Access Compliance Report

Public Rights-of-Way

Intersection ID: 46196	Main Street: FERNSPRAY_RD	Cross Street: LUSTRE_RD	Location: NW
ADA ID: 5935B9248122	Ramp Type: PerpDiag	Initial Pass/Fail: Pass	Overall Compliance: No
		Severity Score: 20

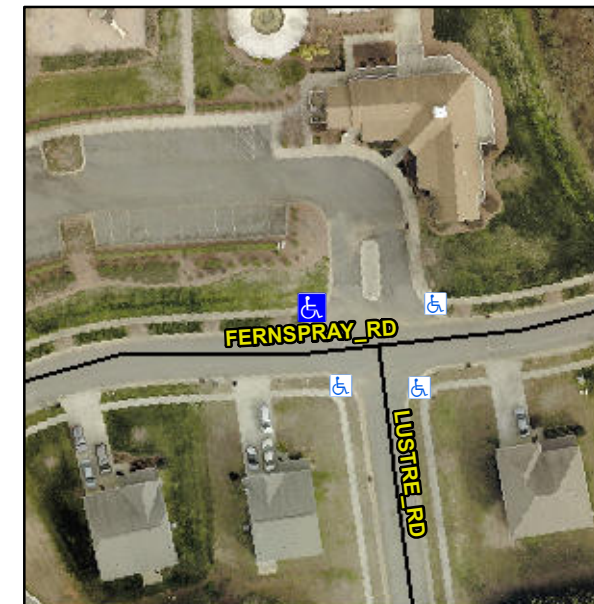
Not Found, R304.2.2-Perp, R304.3.2-Para, R304.5.3, R305.2, R302.7, R302.7.2, R304.5.4

Compliance	Description	Data	Compliance	Description	Data
N/A	Ramp Length (in)	27.5	Yes	Ramp Slope (%)	7.5
Yes	Ramp Width (in)	48.0	Yes	Ramp XSlope (%)	1.2
N/A	Flare Type LT	Sloped	N/A	Flare Type RT	N/A
N/A	Flare Slope LT (%)	8.6	N/A	Flare Slope RT (%)	6.0
N/A	Flare Traversable LT?	No	N/A	Flare Traversable RT?	No
Yes	Landing Length (in)	49.0	Yes	DWS Provided?	Yes
Yes	Landing Width (in)	48.0	Yes	DWS Contrast?	Yes
No	Landing Slope (%)	5.6	Yes	DWS Length (in)	24.0
No	Landing X Slope (%)	2.2	Yes	DWS Full Width?	Yes
N/A	Landing Curb? (Y/N)	No	No	DWS Offset (in)	4.0
N/A	Shared Landing?	No			
No	Gutter Ponding?	Yes	No	Gutter Slope (%)	15.3
No	Gutter Lip Ht (in)	1.3	Yes	Gutter X Slope (%)	0.4
N/A	Painted X Walk1?	No	N/A	Painted X Walk2?	No
	X Walk 1 Direction	To S		X Walk 2 Direction	To E
N/A	X Walk 1 Width (in)	N/A	N/A	X Walk 2 Width (in)	N/A
	X Walk 1 Slope (%)	1.8		X Walk 2 Slope (%)	3.8
	X Walk 1 X Slope (%)	3.8		X Walk 2 X Slope (%)	0.6

Remove & Replace Curb Ramp With Two New Directional Ramps or Equivalent. Remove & Replace Gutter.
